RESPONSE TO REQUEST FOR ADDITIONAL INFORMATION

APR1400 Design Certification

Docket No. 52-046

RAI No.: 332-8382
SRP Section: 03.08.03 - Concrete and Steel Internal Structures of Steel or Concrete Containments
Application Section: 3.8.3
Date of RAI Issue: 12/14/2015

Figure 1. Typical section of IRWST and HVT

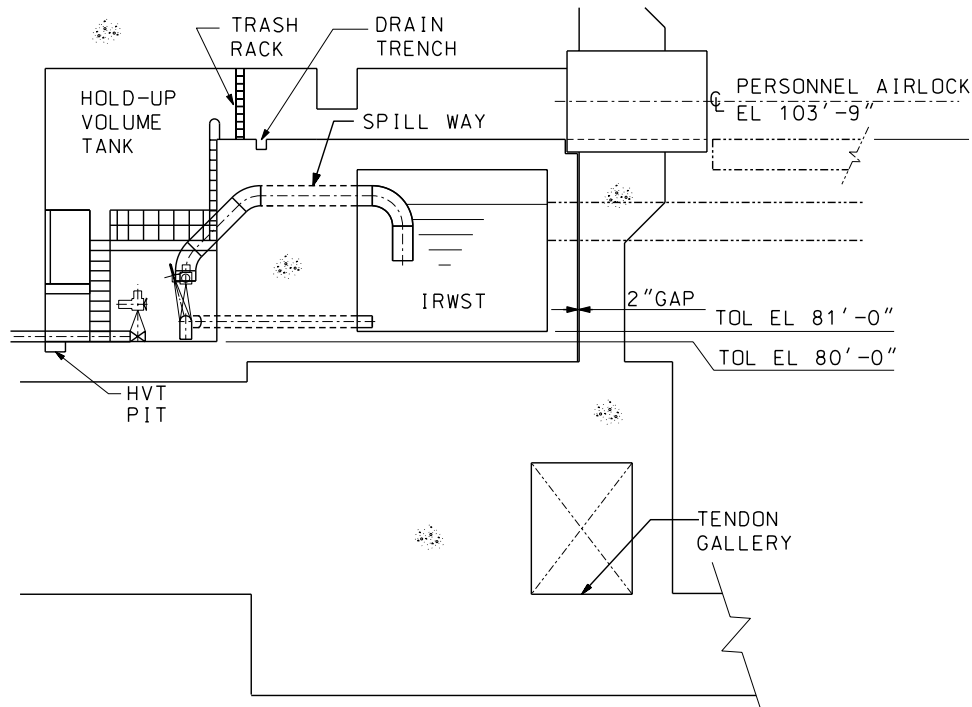
- a. Describe and provide associated design drawings of leak chase channels in the containment liner plate, the IRWST, and the HVT liner plates.
- b. How and where are the leaked borated-water from IRWST and HVT leak chase channel systems collected? In case of blockage from of the crystalized boron in a leak chase channel collection system, how can this blockage be opened prior to spilling borated water into the adjacent reinforced concrete.

An elevation view of a typical section of the IRWST and the HVT is shown in Figure 1 (extracted from DCD Figure 1.2-2):

The leak chase channel collection system is not needed for the HVT because the HVT does not normally store borated water. Instead, the Trisodium Phosphate (TSP) is placed in baskets mounted on the wall of the HVT to be dissolved by the containment spray water during post-accident condition and without any operator action. Under post-accident conditions, water from breaks and containment spray is collected in the HVT and then flows into the IRWST through the IRWST spillways, as shown in Figure 1.
